STAFF RECOMMENDATION

2224 Lindell Avenue

Application: New Construction-Infill

Description of Project: Application is to construct a single-family infill.

METRO PLOT PLAN

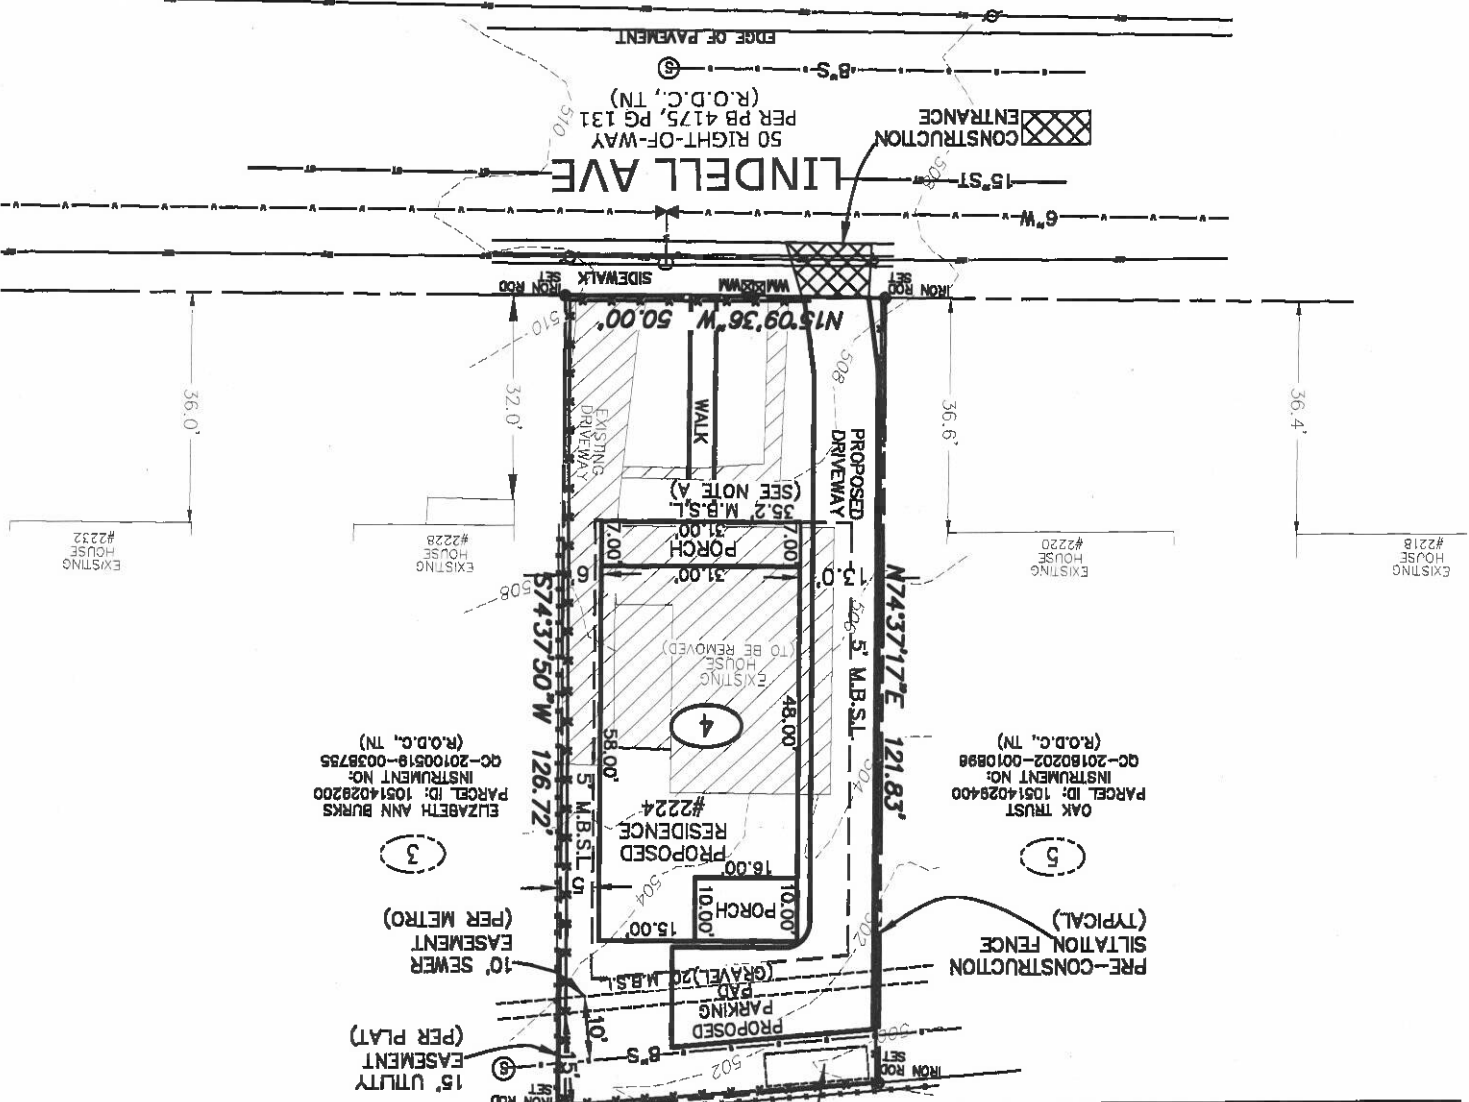
Setback & Rhythm of Spacing: The proposed infill meets all base zoning setbacks. It will be five feet (5') or more from each of the side property lines, and more than twenty feet (20') from the rear property line. The front edge of the porch is in line with the non-contributing houses on either side. However, the front porch edge does not align with the front porch edge of 2236 Lindell Avenue, the other infill proposed for this street, only a couple of houses down. Most of the surrounding homes are non-contributing and the front setback varies for the contributing homes that do exist on this side of the street. Staff finds that the front setback for the two new infill projects, 2224 and 2236 Lindell should align, thereby, establishing the setback for all future projects on this street. Staff finds the front setback should be determined by the setback that is most common to the other contributing homes on this side of Lindell Ave at 2308 Lindell through 2314 Lindell.

1. Alignment of the front setbacks of 2224 and 2236 Lindell; the new established setback should be determined by the setback that is most common to the contributing buildings at 2308-2314 Lindell Avenue.
2. Staff approve masonry samples;
3. Staff approve all windows and doors prior to purchase and installation;
4. Staff approve the roof material and color;
5. Staff approve cladding material, texture, and color;
6. The HVAC shall be located behind the house or on either side, beyond the midpoint of the house;
7. Utility meters shall be located on the side of the building, within 5' of the front corner or on the rear or rear-side within 5' of the rear corner; and,
8. Alternative mechanical and utility locations must be approved prior to an administrative sign-off or building permit.

FRONT ELEVATION

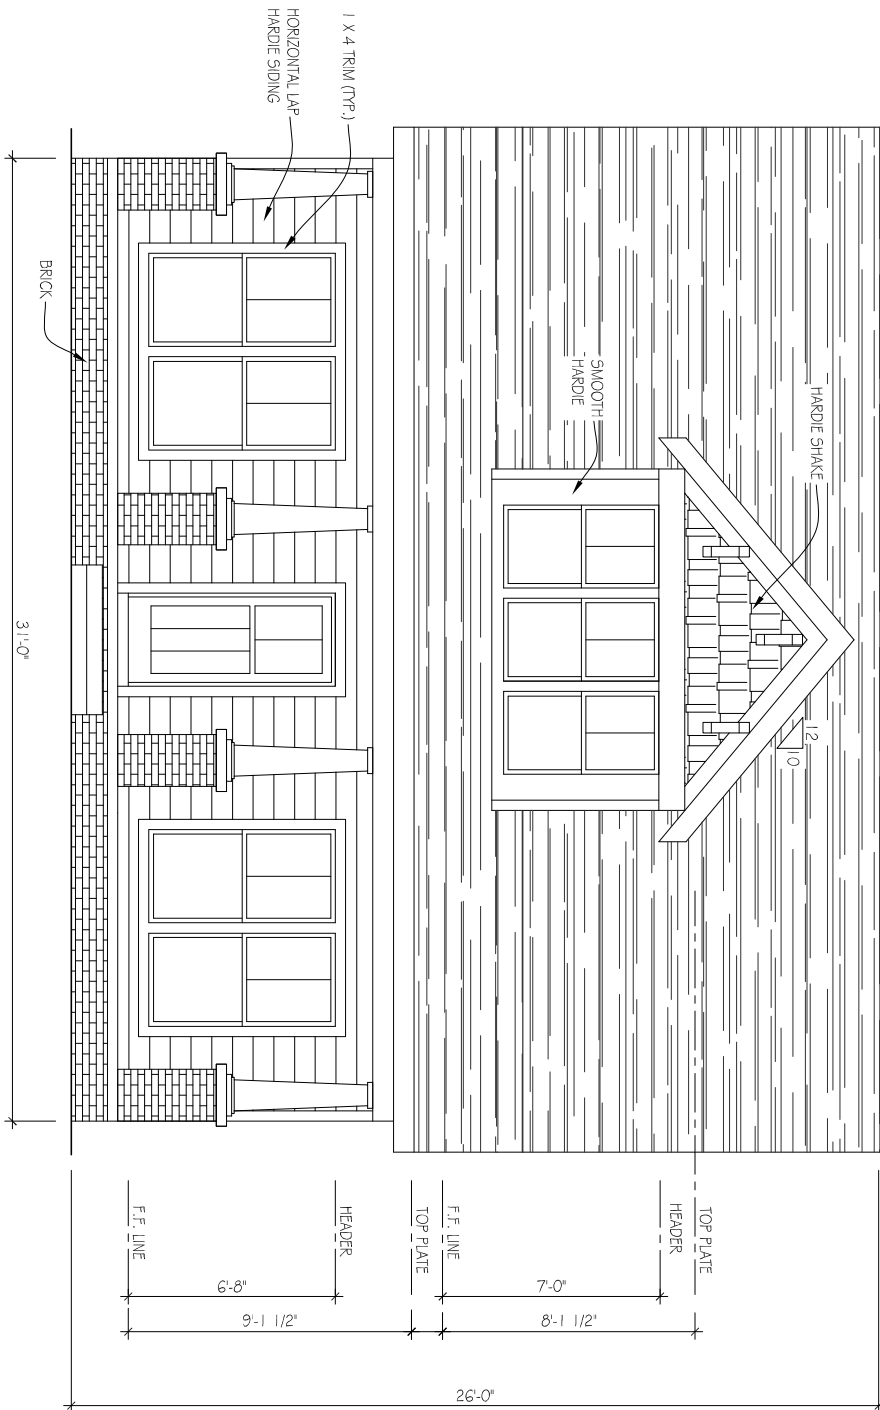
*Siding is shown as a lap siding with corner boards, but the reveal was not indicated. In addition to review of the material, staff recommends that the reveal not exceed five inches (5"). Staff recommends that the siding be smooth, without an embossed grain.

Staff recommends that paired windows have a 4"-6" mullion between.

Roof form: The proposed primary roof form is a side gable roof with a 6/12 slope and a front dormer with a 10/12 slope. Side gable roofs are a common roof form on contributing homes of the Woodland-in-Waverly district and the pitch meets the minimum requirement for the district. Therefore, staff finds that the proposed roof form meets section III.B.2.e of the design guidelines.

Proportion and Rhythm of Openings: The windows on the structure are all generally twice as tall as they are wide, thereby meeting the historic proportions of openings. There are no large expanses of wall space without a window or door opening. Staff finds the project's proportion and rhythm of openings meet Section III.B.2.g. of the design guidelines.

Staff recommends approval of masonry, all windows and doors, the roof material and color, cladding material and color prior to purchase and installation. With staff's final approval of all final material choices, staff finds that the infill's materials meet Section III.B.2.d of the design guidelines.
